STAFF RECOMMENDATION 2008 Natchez Trace December 20, 2017

Application: New construction - infill
District: Hillsboro-West End Neighborhood Conservation Zoning Overlay
Council District: 18
Map and Parcel Number: 10411013100
Applicant: A/E Construction, Inc.
Project Lead: Sean Alexander, sean.alexander@nashville.gov

Recommendation Summary: Staff recommends disapproval of the proposed New construction at 2008 Natchez Trace, finding the design would not meet sections II.B.1.a (Height), II.B.1.b (Scale), II.B.1.c (Setbacks) of the design guidelines for New Construction in the Hillsboro-West End Neighborhood Conservation Zoning Overlay

CONTEXTUAL SITE PLAN		H1
Date	12/04/2017	
Drawn by	MP	Scale 1" = 30'-0"

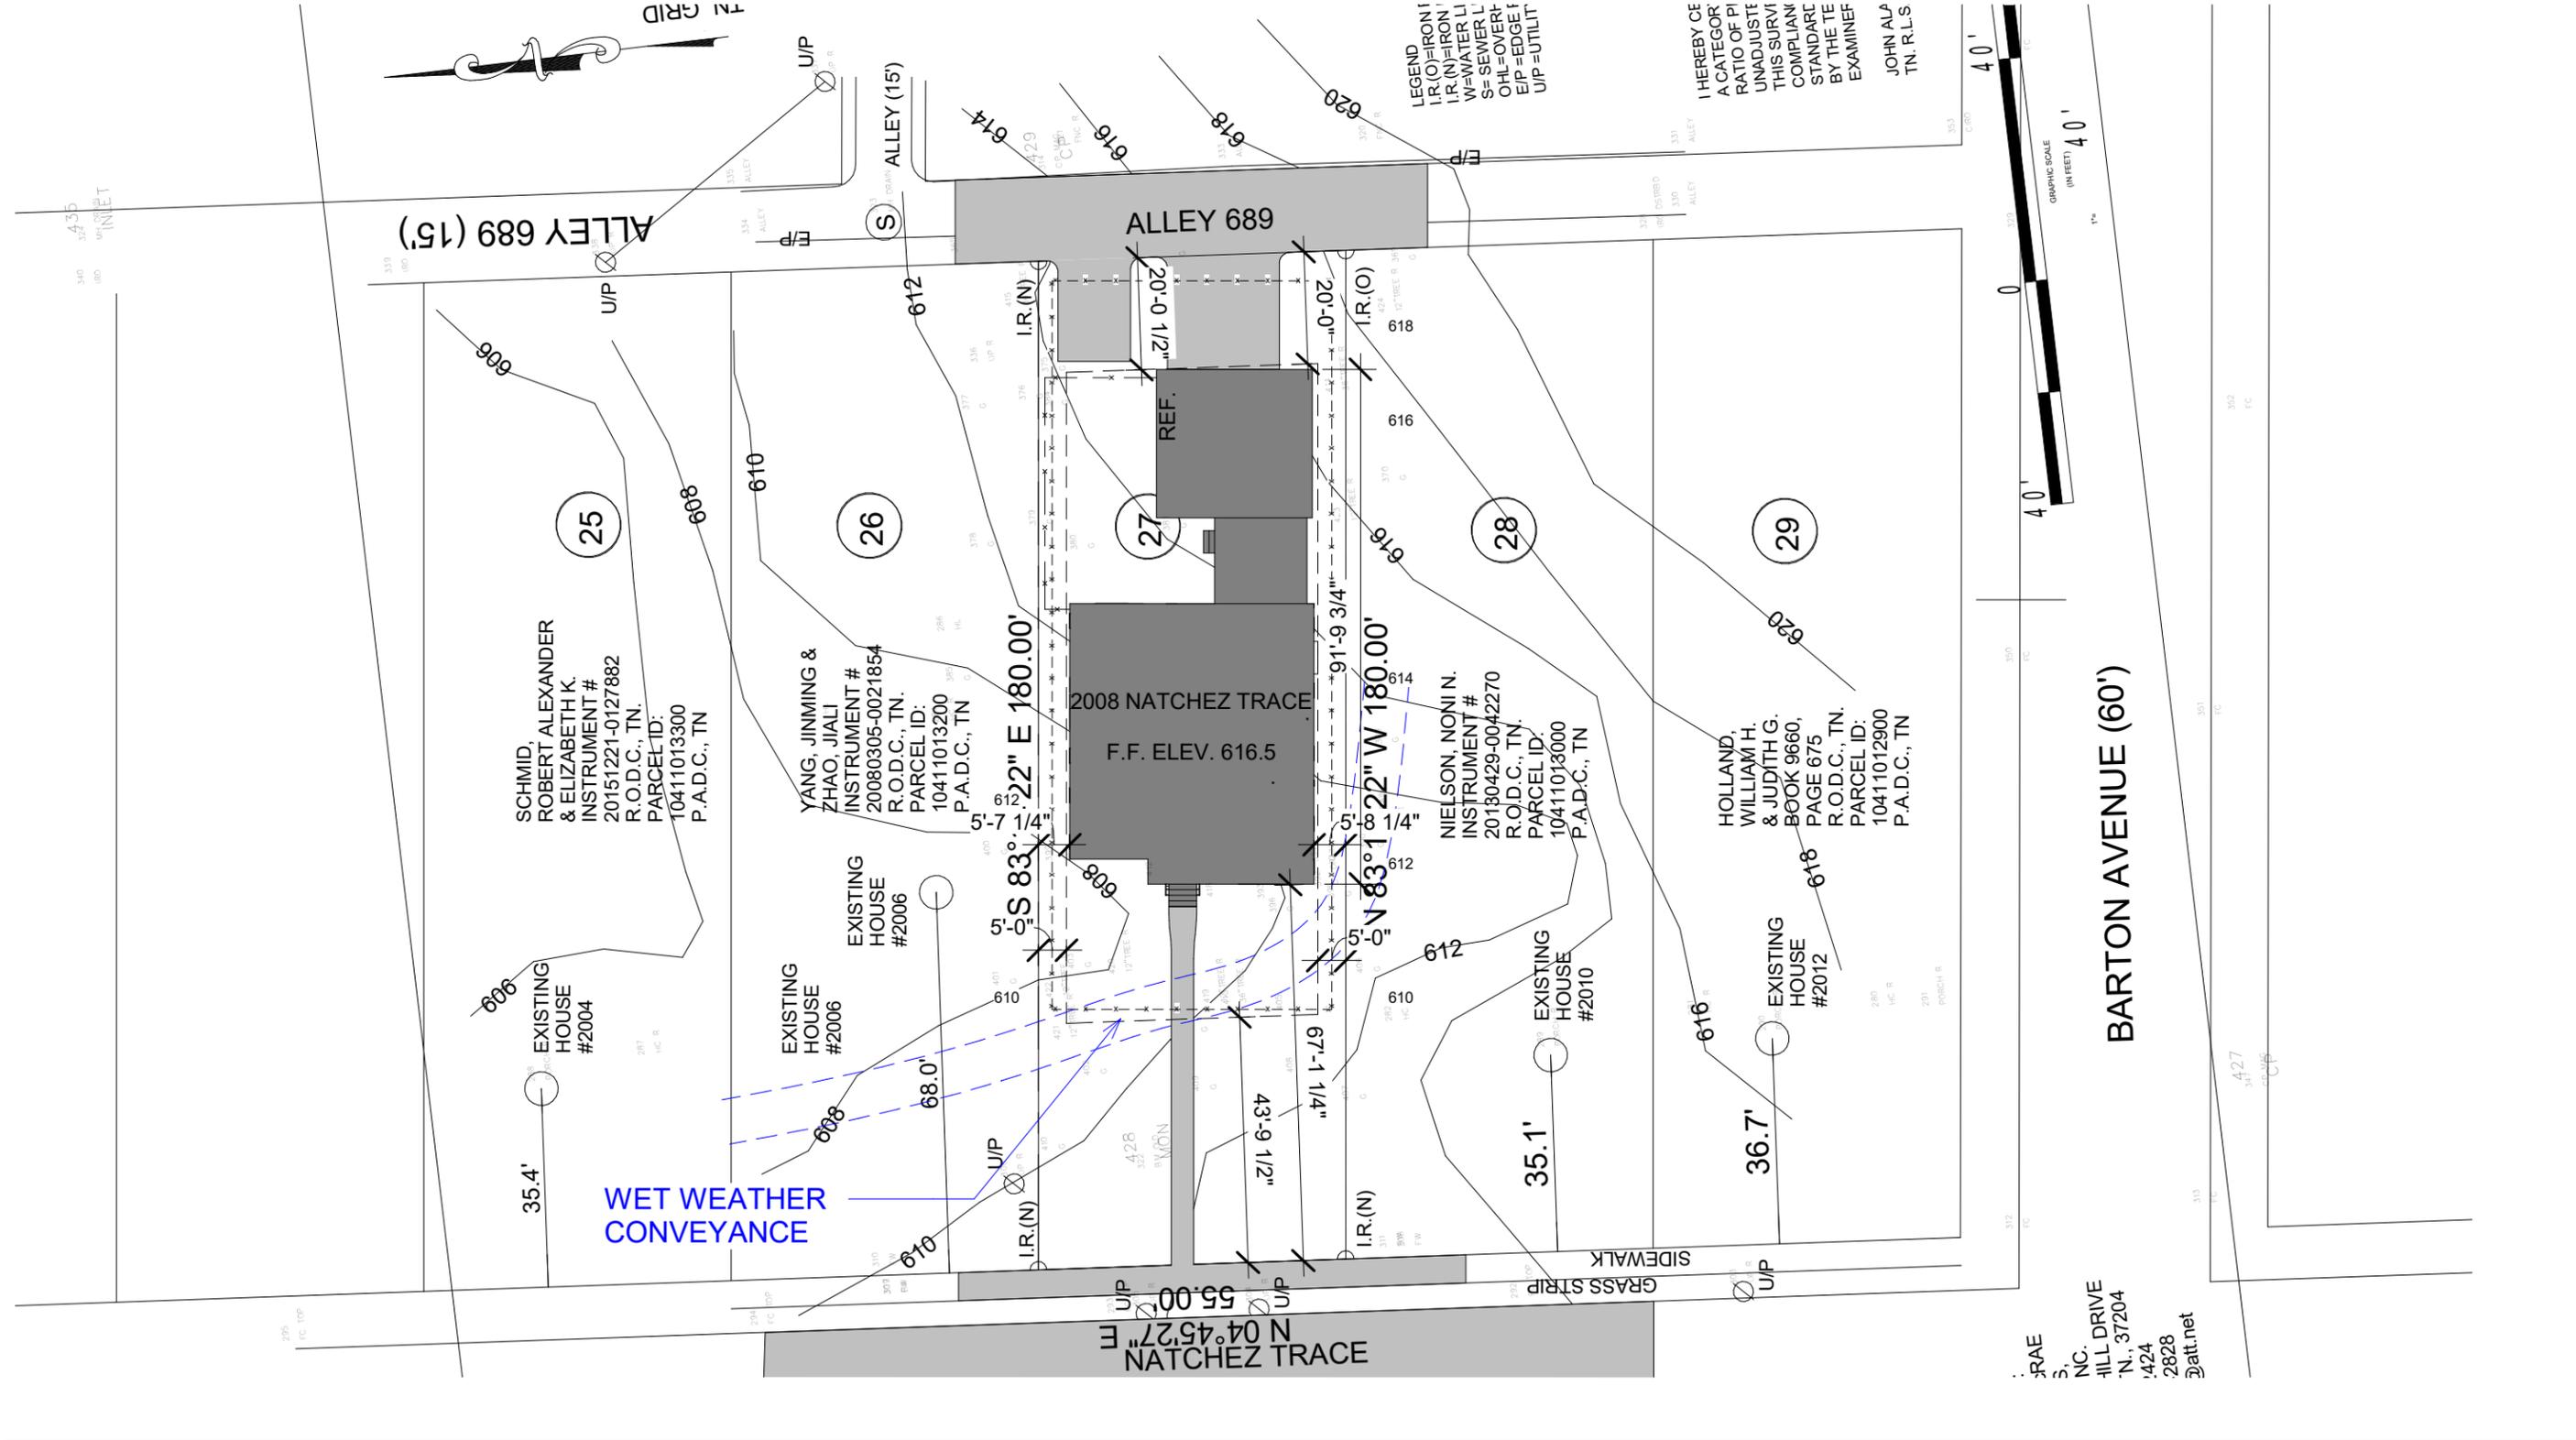
Setback & Rhythm of Spacing: The proposed new building is proposed to have a front setback of sixty-eight feet (68'), whereas historic houses on the block typically have a setback between thirty-five feet (35') and thirty-seven feet (37'). The house that was on this lot previously also had a setback deeper than the surrounding context, as does a non-contributing duplex on the adjacent lot to the left. The non-contributing buildings were likely built so far back because the two lots sit in a natural depression which causes them to occasionally experience stormwater moving across the front half of the lot.

The deep proposed front setback is not compatible with the surrounding historic context. While the slope of the lot may pose an issue for managing stormwater, it is not clear that a setback nearly twice that of the historic context is the best or only solution, or that it would not create other issues for this and other properties. Staff has reached out to the Metro Stormwater department to request more information and advice, but have not yet gotten a response.

Unless it can be demonstrated that building a house with a compatible front setback is not possible, Staff finds that the proposal is not appropriate and does not meet section II.B.1.c of the design guideline.

The applicant is encouraged to seek input from Metro Stormwater and others to determine how a building could be built with an appropriate front setback, and to continue working with MHZC Staff on making the height, scale, and fenestration of the building more compatible with surrounding historic houses.

FRONT ELEVATION		H3
Date	12/04/2017	
Drawn by	MF	Scale 1/8" = 1'-0"

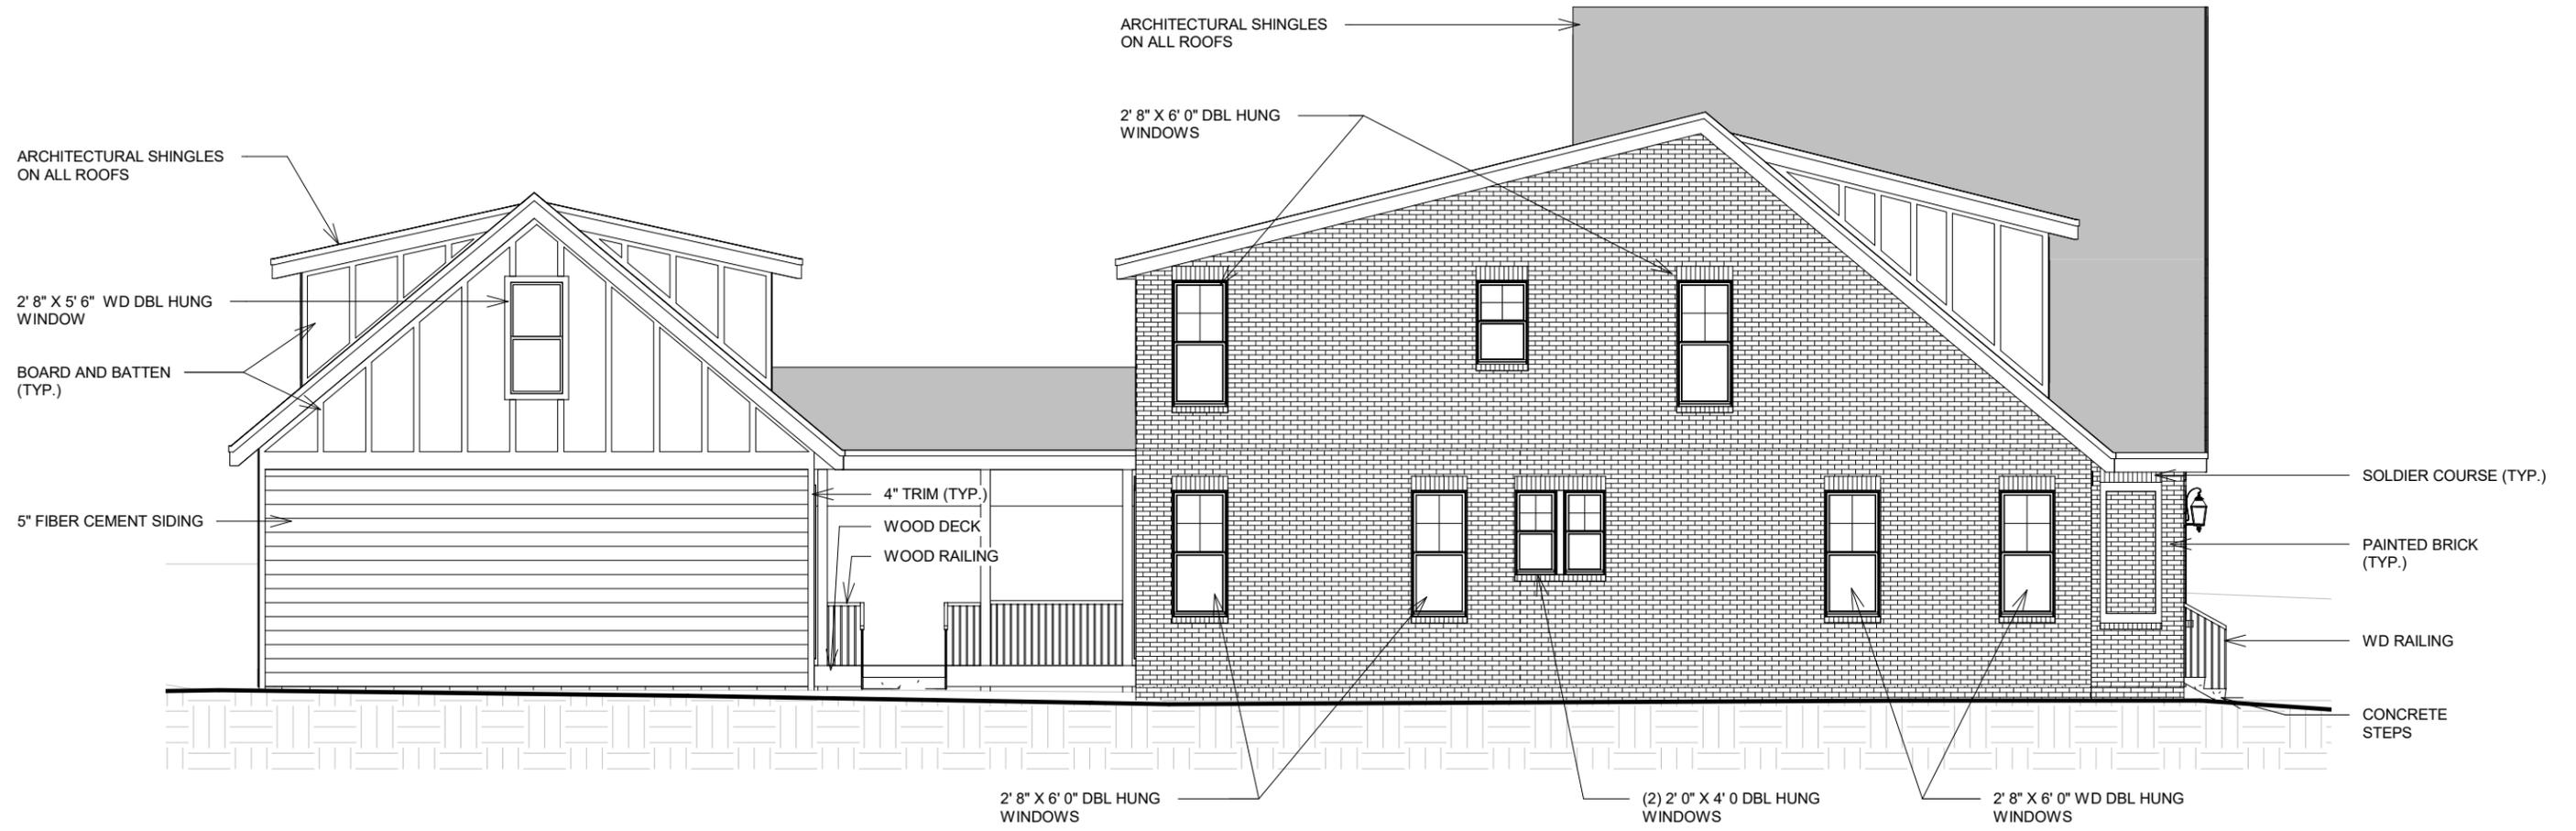
Height & Scale: The proposed new house will be partly one and one-half stories and part two-stories, with the peak of a front-gabled roof thirty-one feet, six inches (31'-6") tall above the floor level and the ridge of a cross-gabled roof component twenty-six feet, six inches (26'-6") above the floor level. The front left corner of the house will have an eave height of ten feet (10') above the floor level, but the eaves of the other three corners will be at nineteen feet (19'). These heights would be compatible with historic houses in the surrounding area, which comprises mainly one and one-half-story and some two-story houses ranging from twenty-four feet (24') to thirty-two feet (32') tall. However, the plans show the floor level to be approximately one foot (1') above grade but because of the significant slope of the lot it is likely to be several feet taller on at the front. Because the grade is not accurately depicted on the drawings, it is not possible to accurately determine what the actual height of the building will be.

The form of the house will resemble a Tudor Revival style house with an asymmetrical front façade. The primary mass will be forty-four feet, five inches (44'-5") wide and the depth will be fifty feet (50'). Historic houses on comparable lots nearby typically range between thirty-five feet (35') wide and thirty-nine feet (39') wide, and are less than forty-feet (40') deep.

Roof form: The house will have two primary roof sections, a front-oriented gable with a 14:12 pitch, intersected by a side-oriented saltbox-gable with a 10:12 pitch on the front slope and 3:13 on the rear. The side-gabled roof will have a shed dormer with a 3:12 pitch on the front slope. There are examples of historic houses in the vicinity with more than one roof form or pitch, often on houses comprising elements of more than one style as with the proposed infill. With this application, however, Staff finds that the disparities between the heights and pitches of the proposed roofs too great, resulting in a shape that would contrast with the forms of historic houses. Staff finds the roof of the proposed infill is not compatible with surrounding historic houses and does not meet section II.B.1.e of the design guidelines.

Proportion and Rhythm of Openings: The windows on the front elevation will be twice as tall as they are wide, arranged in sets of three with mullions in between, which is a common pattern on historic houses. The front windows are shown with shutters. Shutters historically could be closed to cover and protect a single window or a pair, and are sized accordingly to fit the window opening. This would not be possible with the proposed three-part window configuration. Staff recommends that the shutters shall be eliminated or that the windows are revised from three-parts to pairs. The front and side elevations will have regularly spaced windows with no large expanses of walls without any opening. The windows on the left elevation will have typical proportions and orientation, as will all but four windows on the right side. The right elevation shows two square windows on the upperstory and two thin vertical “ribbon” windows on the first story. Irregularly sized windows may be appropriate further to the rear where there would be less visibility, but not in the proposed location. With conditions that the shutters are eliminated and that the window sizes are revised to be more typical of windows on historic houses, Staff finds that the project will meet section II.B.1.g of the design guidelines.

LEFT ELEVATION		H4
Date	12/04/2017	
Drawn by	MF	Scale 1/8" = 1'-0"

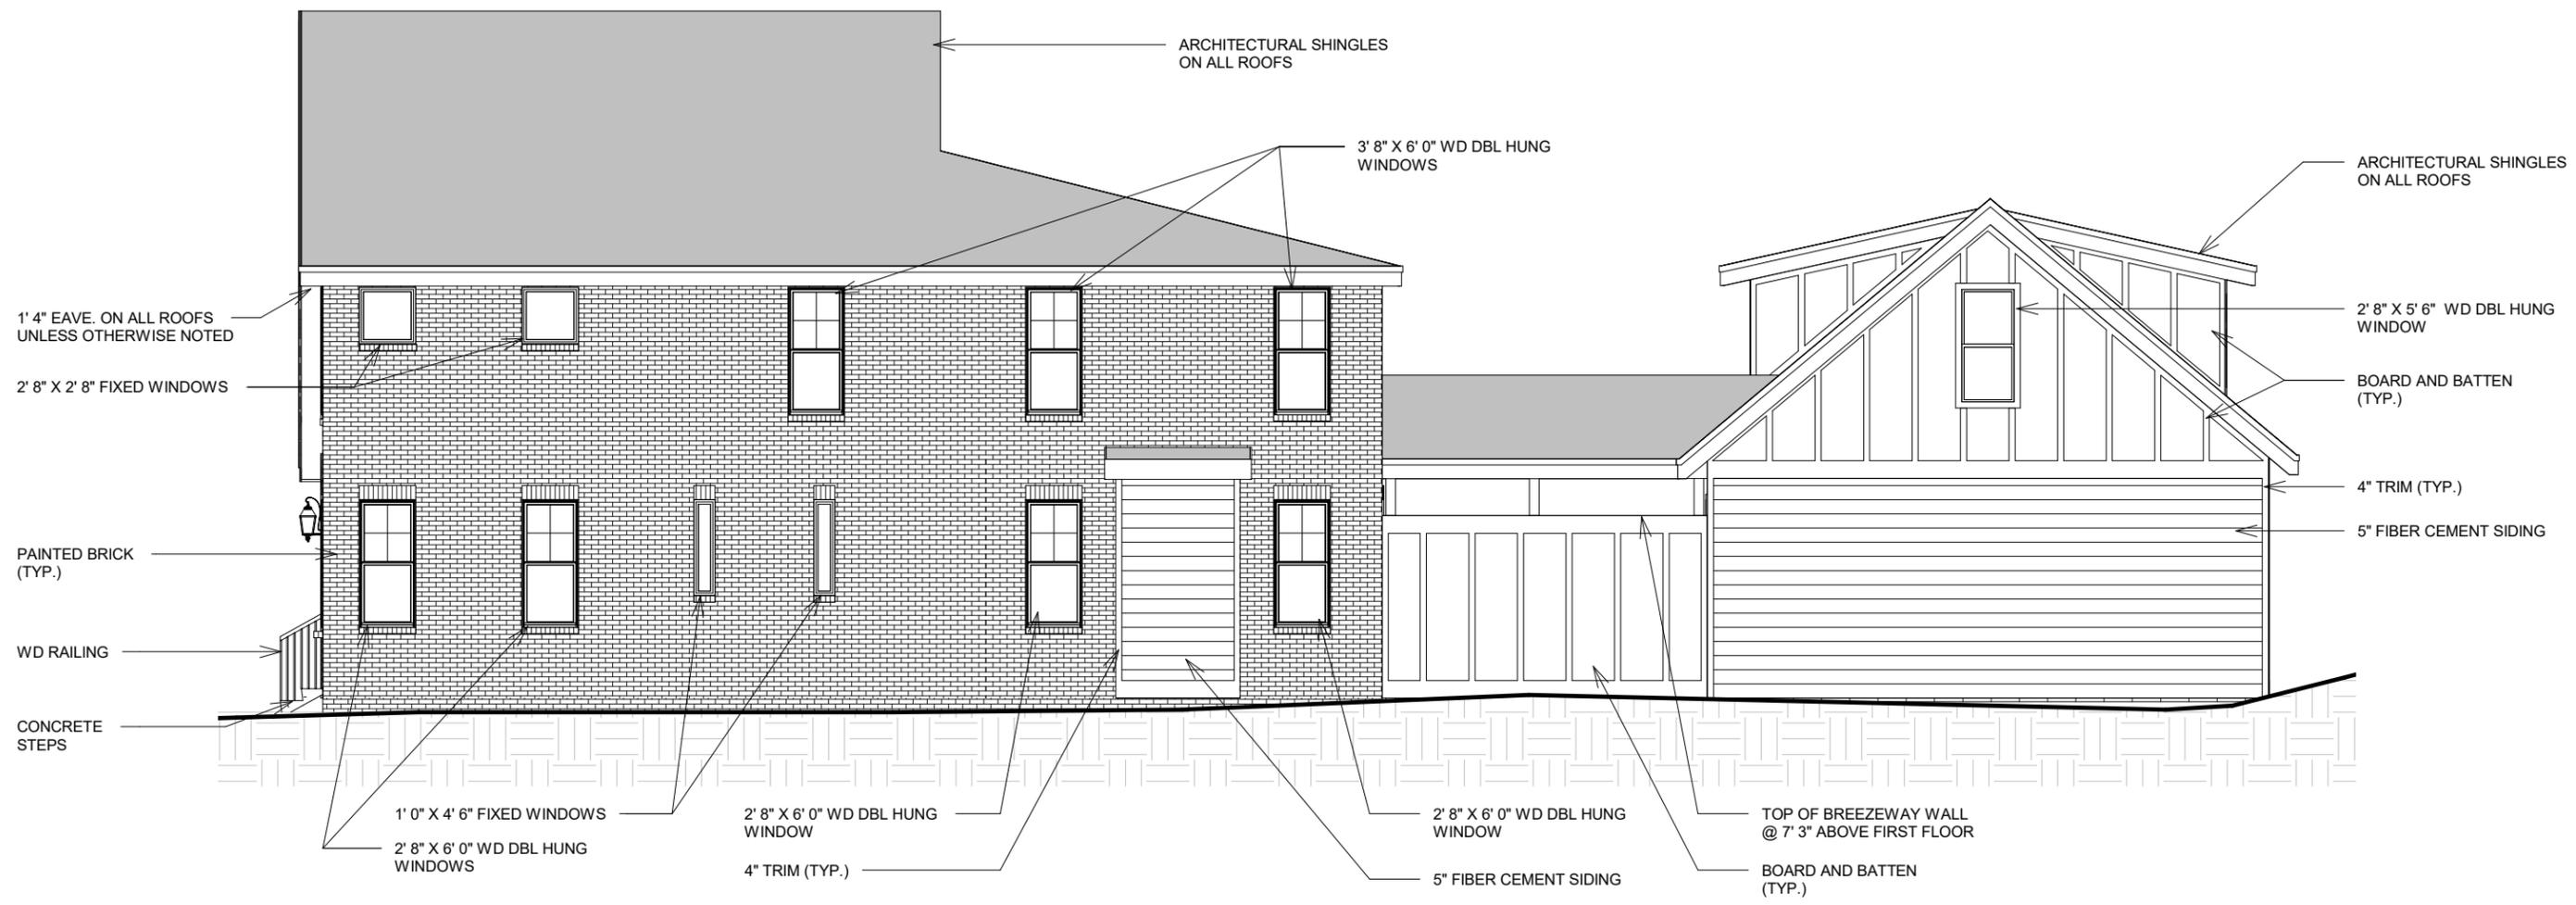
The proposed house would also include a one-story rear porch and attached garage at the rear, which brings the total depth to over ninety-feet (90'). Attached garages are not typical of the surrounding historic neighborhood, with the exception of a small number of basement level garages on lots that drop significantly toward the rear. The MHZC has approved some garages to be connected to a principal building by a breezeway that is less than six feet (6') wide and has open sides. The porch connecting the house and garage in the current proposal would be sixteen feet (16') wide, open on one side with a wall on the other. While the garage would be in the appropriate location for a detached outbuilding, situating the house thirty-five feet (35') farther back on the lot than is typical of the street forces the two to be inappropriately connected to each other. In addition, the proposal does not meet the requirement that a principal house be at least twenty-feet (20') from an outbuilding.

Staff finds that the height, width, and depth of the proposed infill with an attached garage would not be compatible with surrounding historic houses and that the project does not meet section II.B.1.a and II.B.1.b of the design guidelines.
